# Work Order ID 95318

Item Name: Crosstube Fwd

DRAWING NO. D206-667-143	TITLE CROSSTUBE ASS'Y (206L HIGH FWD)	REV. C	DART AEROSPACE LTD ENGINEERING ORDER		D.E.O. NO. D206-667-143-C-1	SHEET NO. SHEET 1 OF 1	SCALE NTS
DRAWN 97	CHECKED ASS	MFG. APPR. 128	APPROVED WD	DE APPR. H			
DATE 11.07.15	DATE 11.07.20	DATE 11.07.21	DATE 11/07/21	DATE 11.07.21

**DETAIL P**  
BONDING STRAP INSTALLATION 2 PL

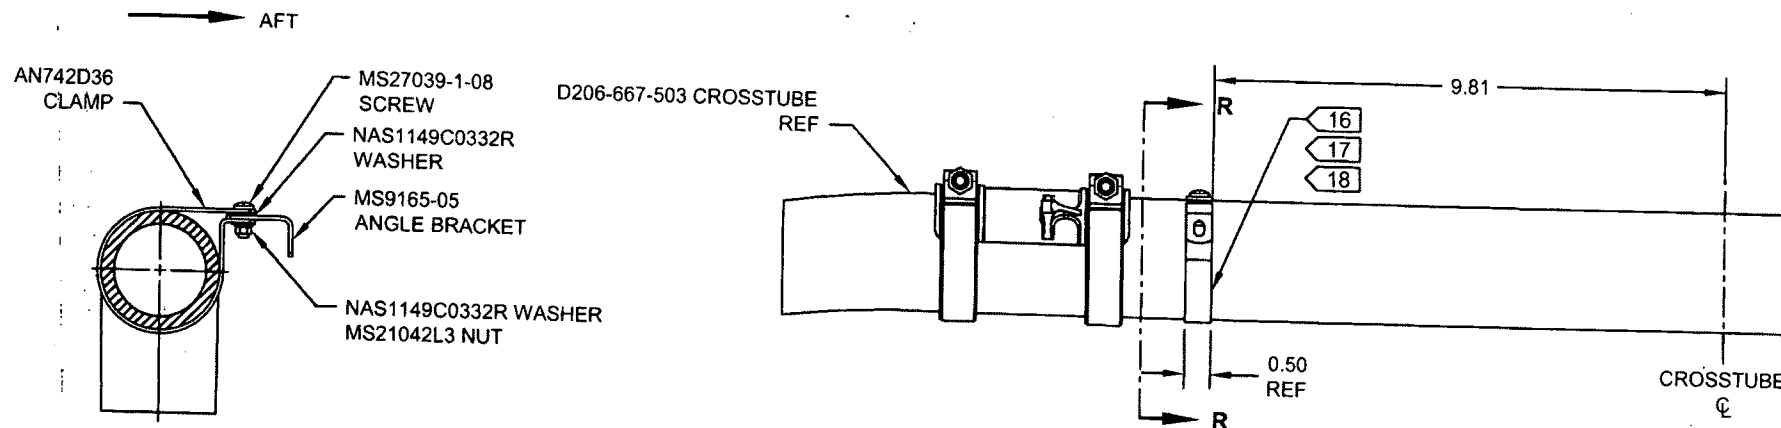
ADD ELECTRICAL GROUNDING STRAP

— ADD

— ADD
